IN THE DRAWINGS

REMARKS

FIG. 13

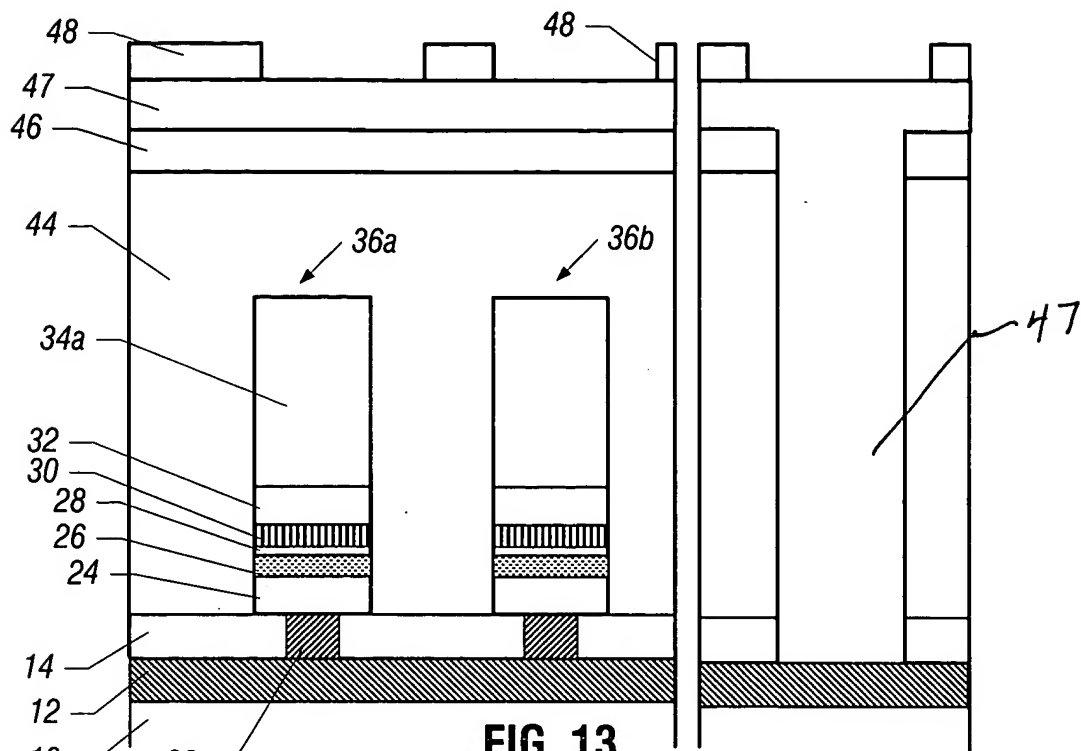
Figure 13 has been amended as indicated in red in the attached annotated marked-up drawing. A replacement sheet of Figure 13 is also attached.

With respect to the objection to Figure 14, it is believed that adding the reference numeral to Figure 13 will clarify the issue. In other words, in Figure 13, the groove in the periphery is filled with the sacrificial light absorbing material 47. See the specification at page 12, line 7.

FIG. 14

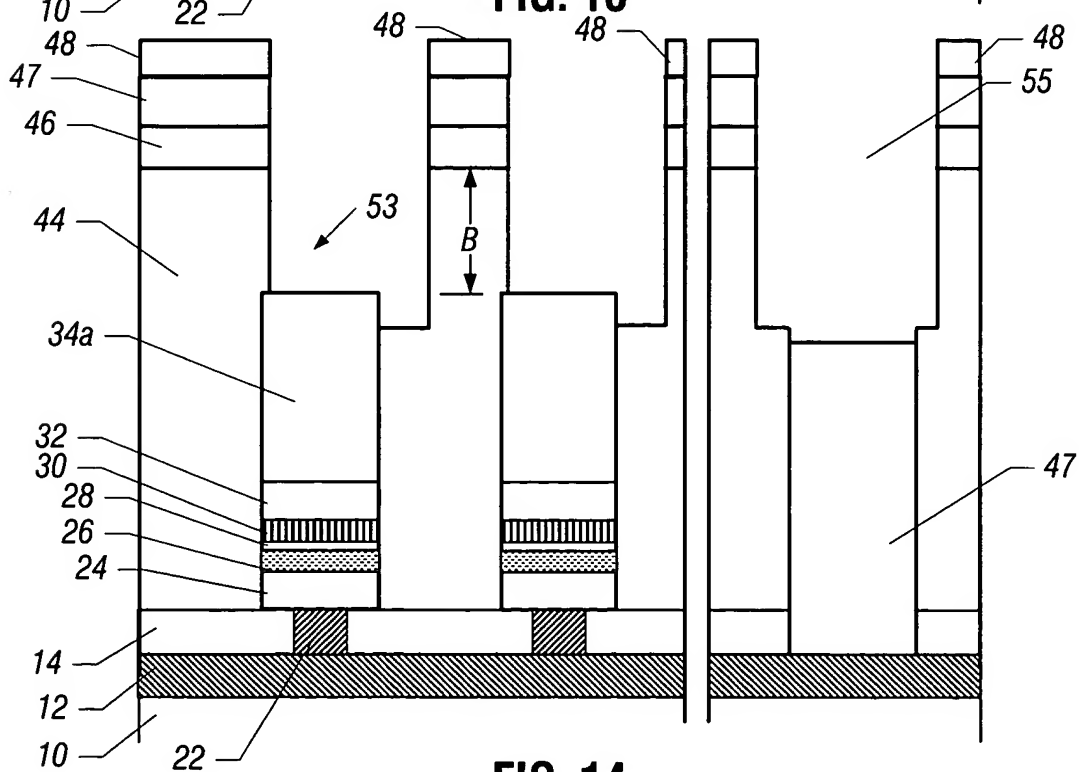
It is also indicated that it is unclear why claim 17 further discloses etching said groove in the periphery into the sacrificial light absorbing material. This is seen by comparing Figures 13 and 14 with the groove 55 resulting in Figure 14.

With respect to the question about why the groove in the periphery could be claimed to be deeper than the groove in the memory array, the groove 55 and 53 may be compared to see that the drawings do show this feature.
